SUBMISSIONS REPORT: **Horsley Road Multi-level Warehouse**

339-349 Horsley Road, Milperra
Lot 140 DP 550194 and Lot 141 DP 550194

SUBMISSIONS REPORT

SSD-45998963

Figure 1. Updated Site Plan (Source: SBA Architects, March 2023)

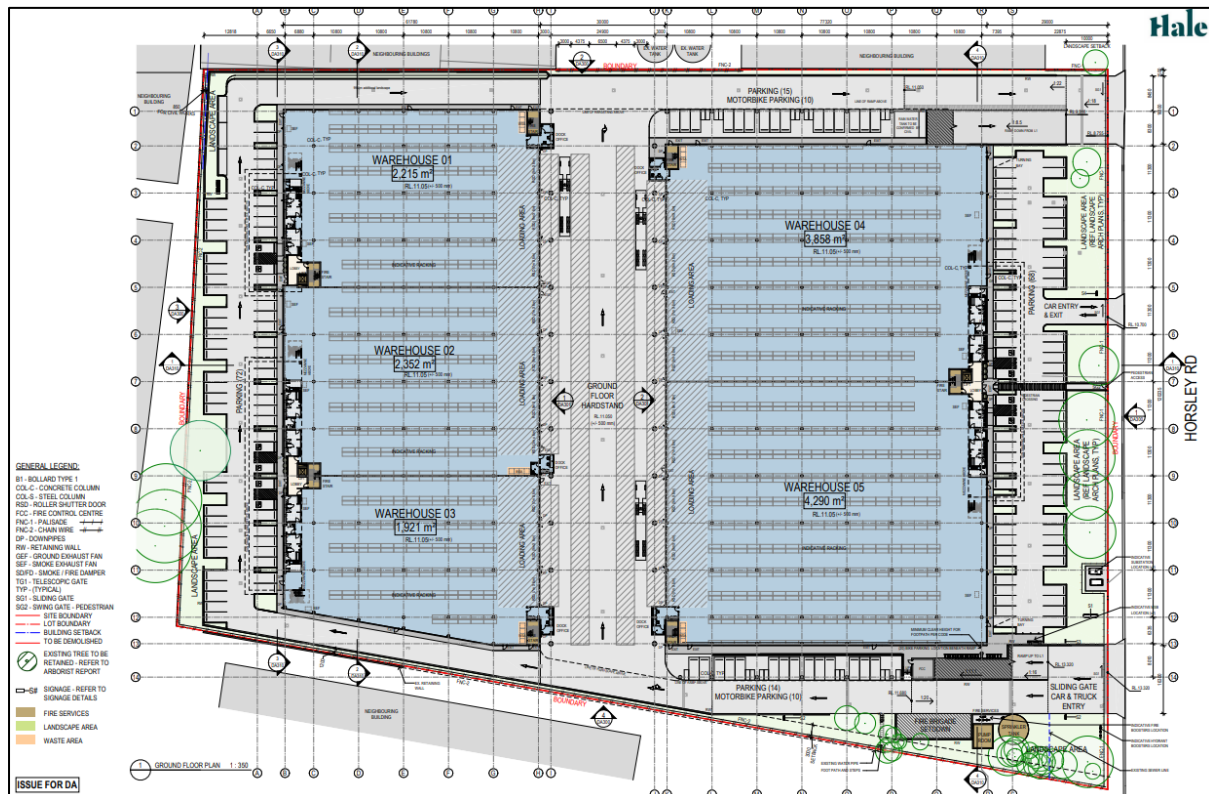
Following the exhibition phase, and upon review of all submissions received, several amendments have been made to the proposal. It is noted that these amendments have also captured changes resulting from more detailed design. The updated site plan is shown in **Figure 1** and the changes are further explained in **PART 3** of this Submissions Report.

- Increased landscaped areas, including:
 - Additional planter box at the Horsley Road frontage pedestrian access
 - Additional deep soil zone at the north-western extent of the site
 - Increased canopy cover from 3,809m² (11.29% of the site) to 4,621m² (13.94% of the site)
- Reduced impact to vegetation, including:
 - Avoidance of impact to Cumberland Plain Woodland
 - Minimised impact to planted native vegetation (Swamp Oak)

- Redesign of the inter-warehouse breezeway roof, and
- Internal alterations to the level one warehouse amenities block have been rationalised to now sit outside the warehouse footprint. The rationalisation of the level one warehouse amenities has reduced the operational safety risk by limiting the number of blind corners and increasing the distance between the amenities block entrances and indicative racking layout. The minor design change increases the operational efficiencies and reduces the operational safety risk of MHE operating around blind corners near the warehouse amenities block.

Figure 6. Height Context – North Elevation (Source: SBA Architects, 2023)

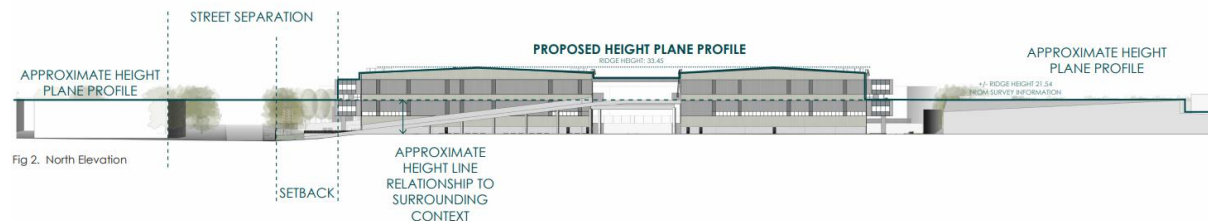
The east elevation (**Figure 5**) holds the most critical view of the street frontage, in response to this importance the proposed development has very little impact to the neighbouring buildings by matching the scale and height profile of the surrounding urban context. Additionally, the warehouse employs an articulation that relates to the height lines of the smaller neighbouring building typologies. The north elevation (**Figure 6**) makes evident the approximate difference in height profile to the adjacent properties across Horsley Road. However this disconnection is minimised through the street separation, building setback and the inclusion of facade articulation that carries the existing height profile through the site. The west facade of the building matches the height profile of the adjacent lots and carries this through to the street frontage.
